(MM3-CBS-REL-PYL)

“Procurement, Supply, Installation, Testing and Commissioning of various Power Supply works including associated Civil works, required for diversion of 220 kV and 33 kV Transmission Lines along with the Transmission towers belonging to M/s Reliance Infrastructure Ltd. in Aarey depot area for Mumbai Metro Line -3”

Addendum No. 1

Date: 27th April 2017

PROJECT:- MUMBAI METRO LINE 3
COLABA-BANDRA-SEEPZ
TITLE:-
SECTIONAL ELEVATION OF
220KV DC TOWER
SCALE: AS SHOWN(A1) DATE:- JAN, 2017
DRAWING NO. :- MM3-CBS-REL-PYL/002A

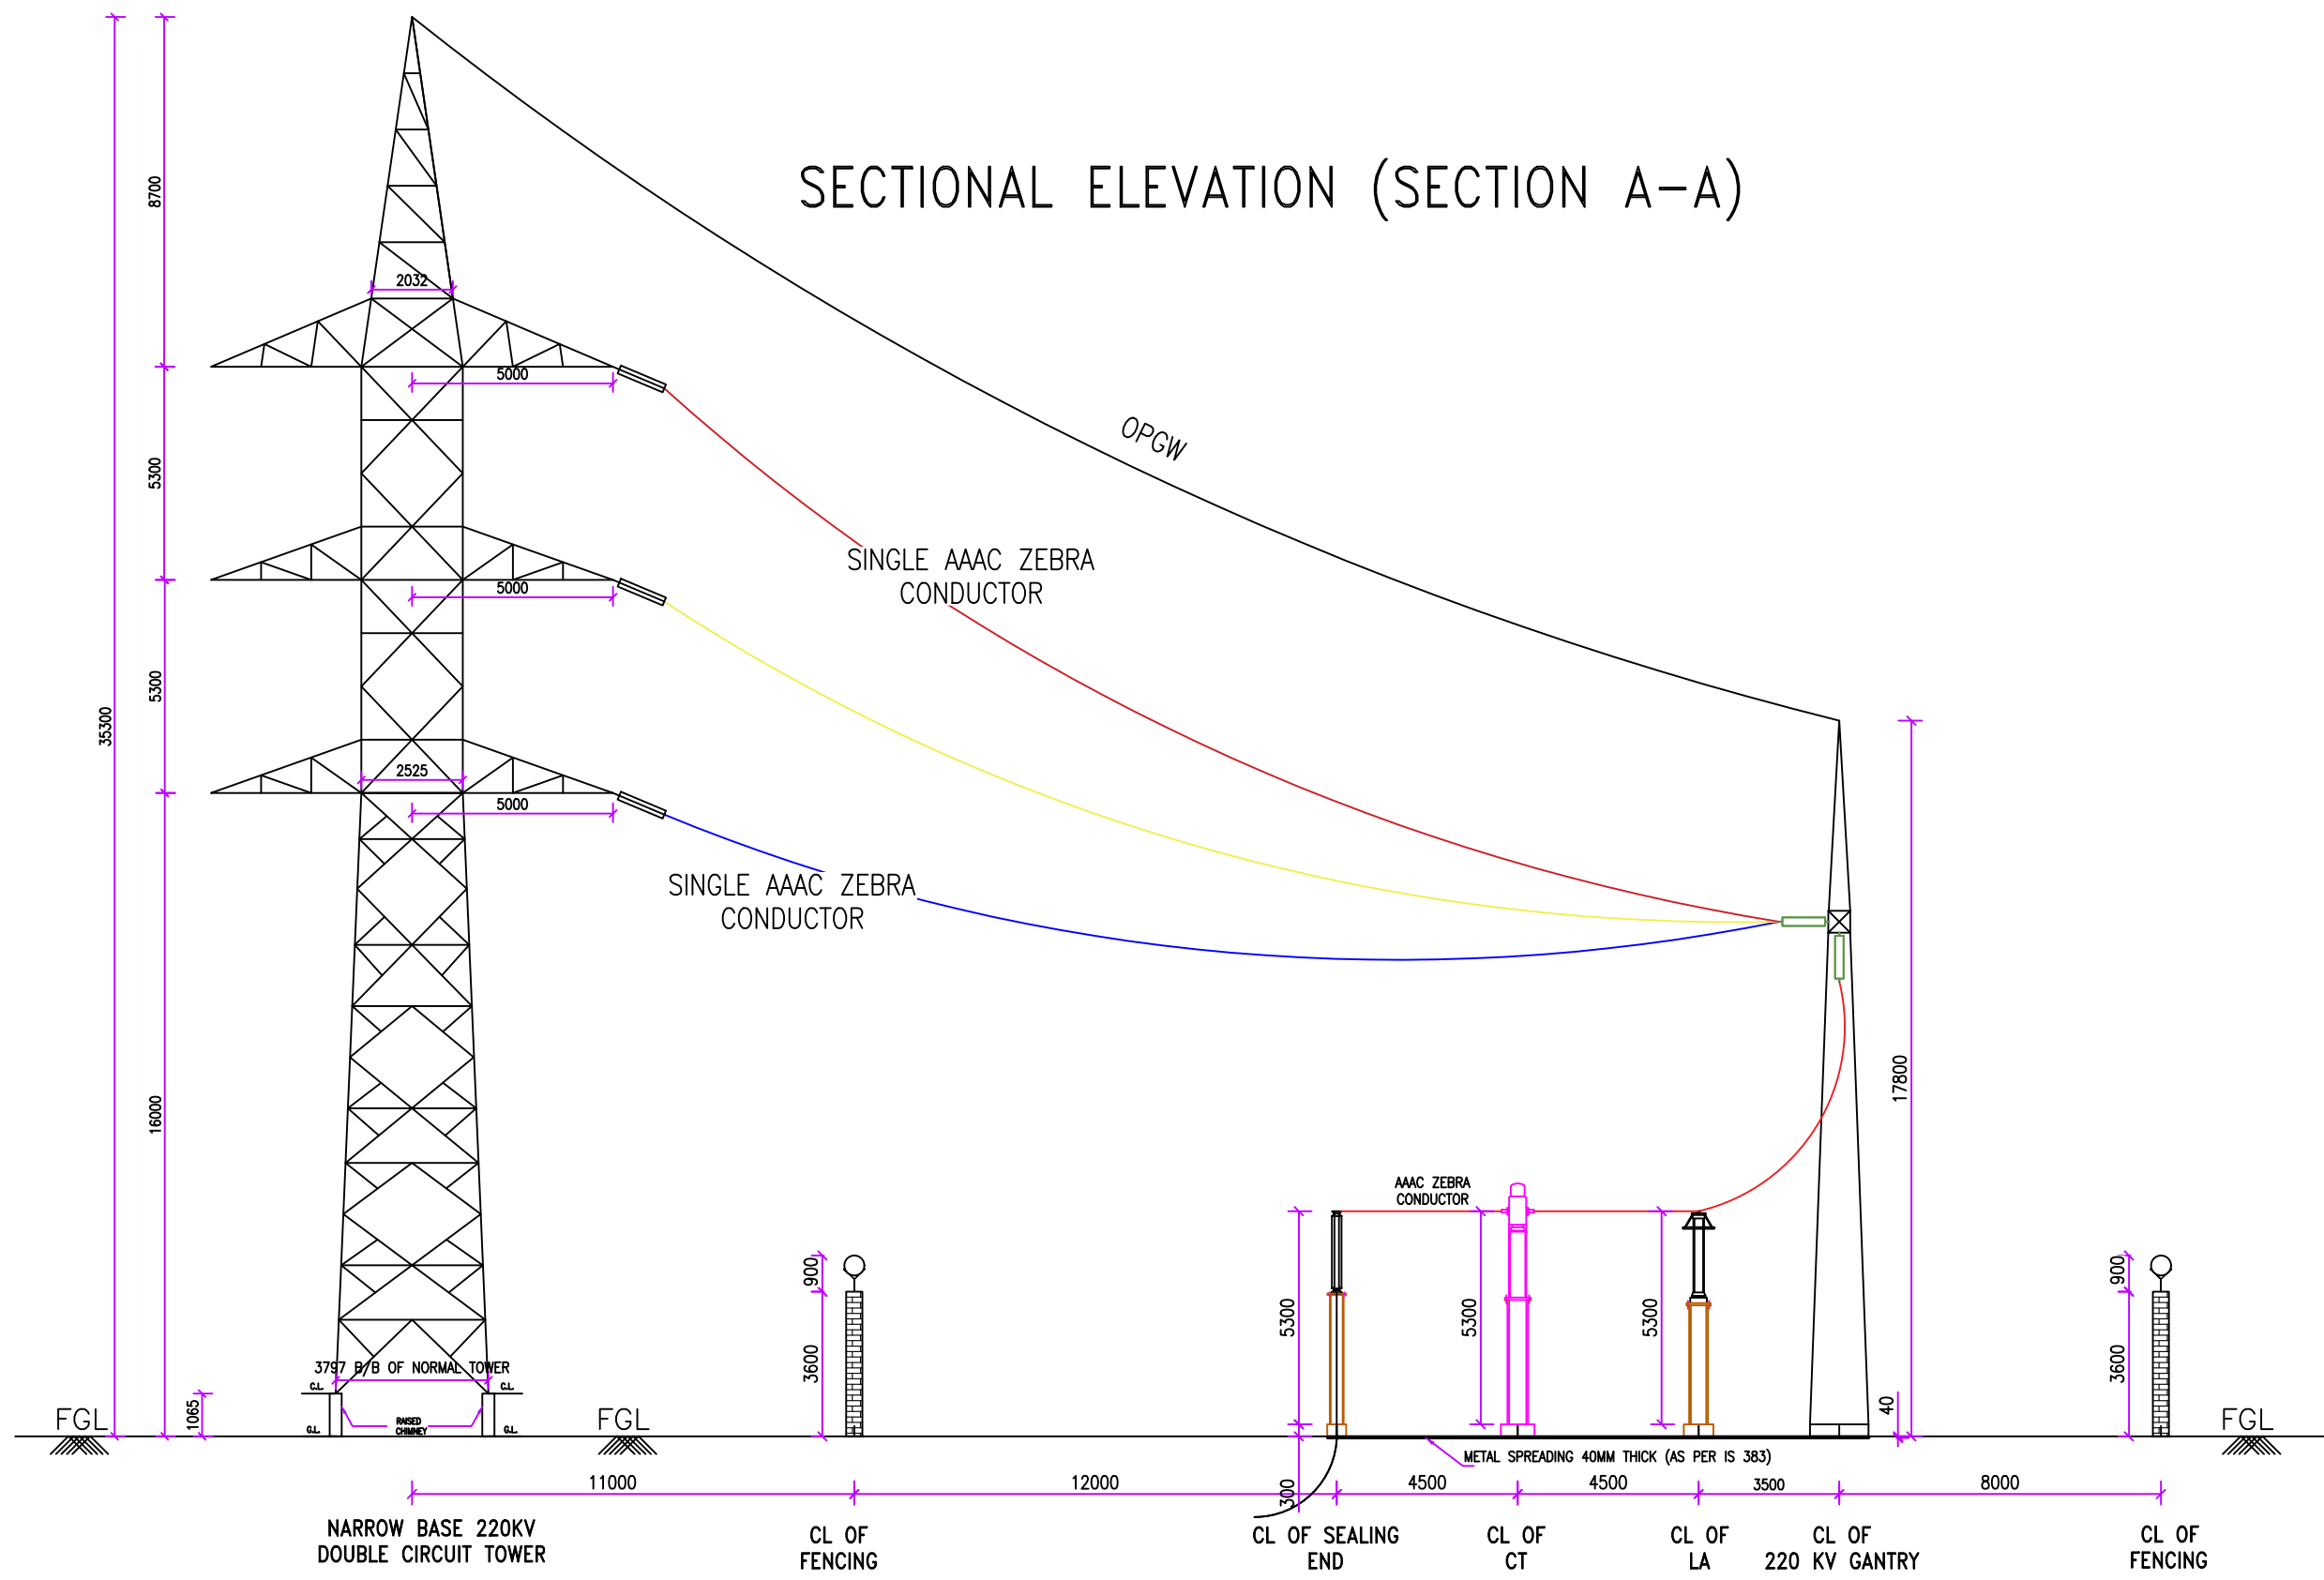
D				
C				
B				
01	27.04.2017	VP	KLS	METAL SPREADING SHOWN & BOUNDARY WALL MODIFIED.
REV.	DATE	PREP.	APPROVED	DESCRIPTION

PROJECT:- MUMBAI METRO LINE 3
COLABA-BANDRA-SEEPZ
TITLE:- SECTIONAL ELEVATION OF
220-33KV MC TOWER
SCALE: AS SHOWN(A1) DATE:- JAN, 2017
DRAWING NO. :- MM3-CBS-REL-PYL/002B

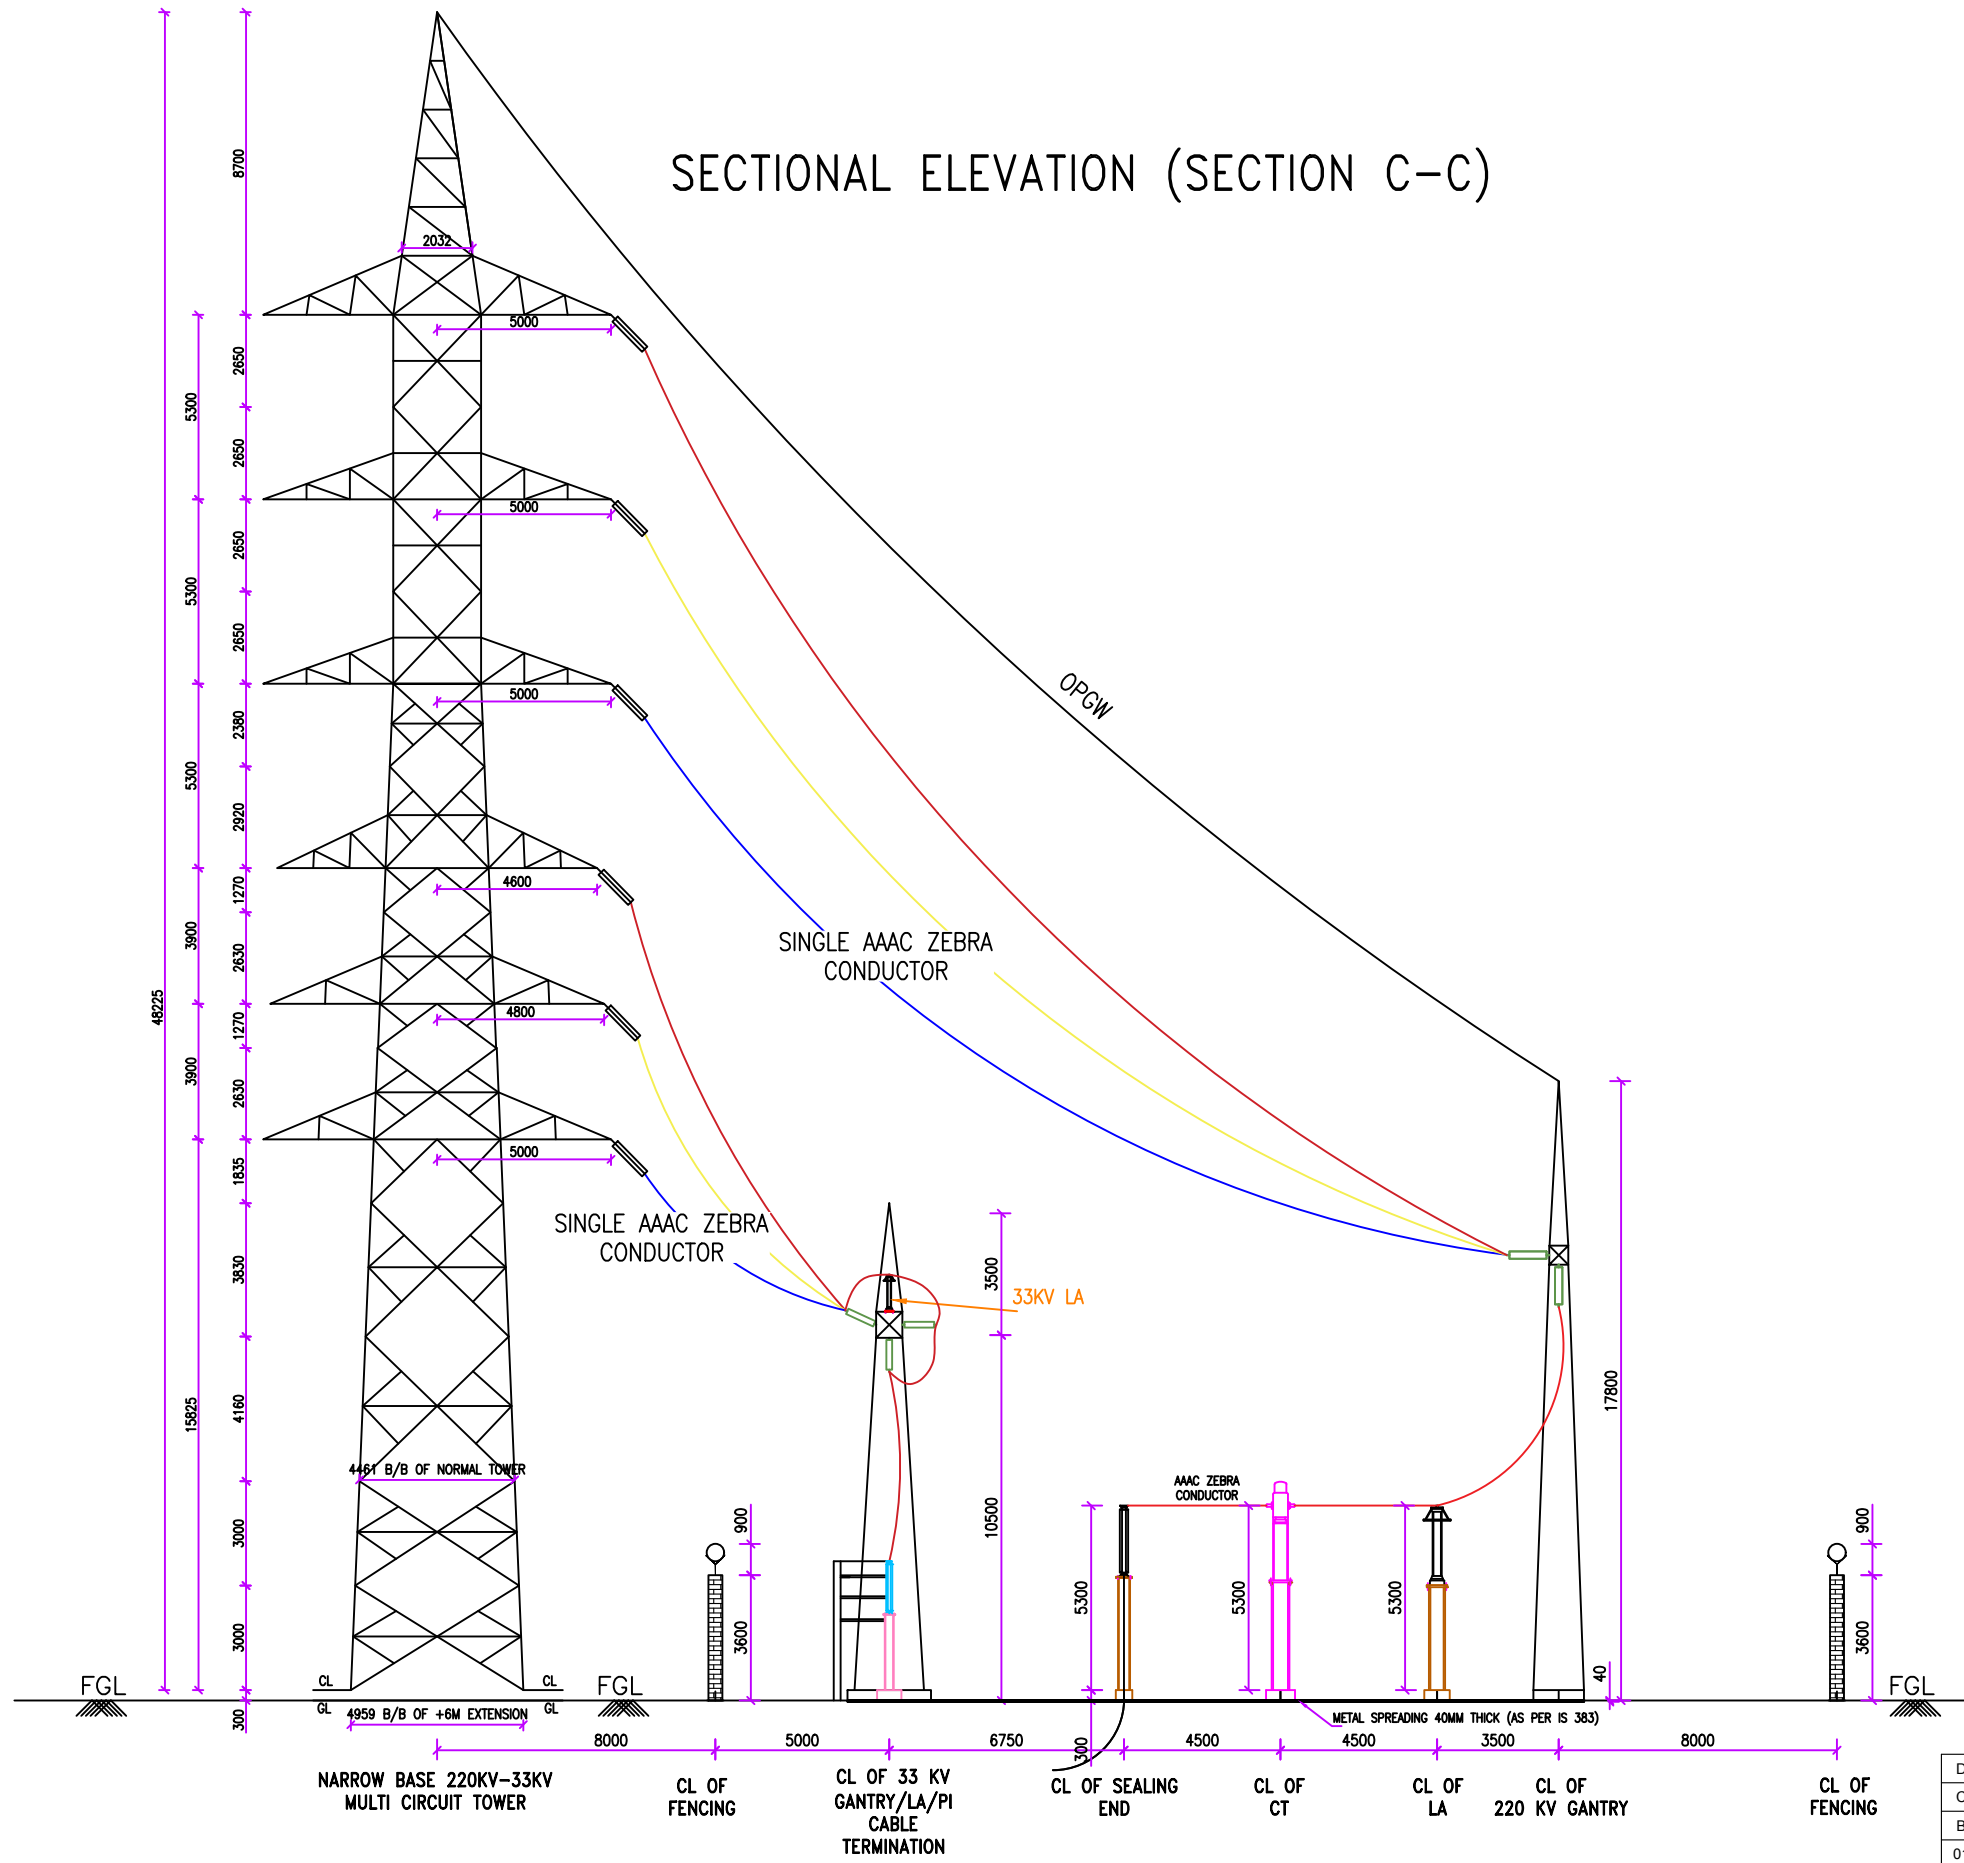
REV.	DATE	PREP.	APPROVED	DESCRIPTION
01	27.04.2017	VP	KLS	METAL SPREADING SHOWN & BOUNDARY WALL MODIFIED.
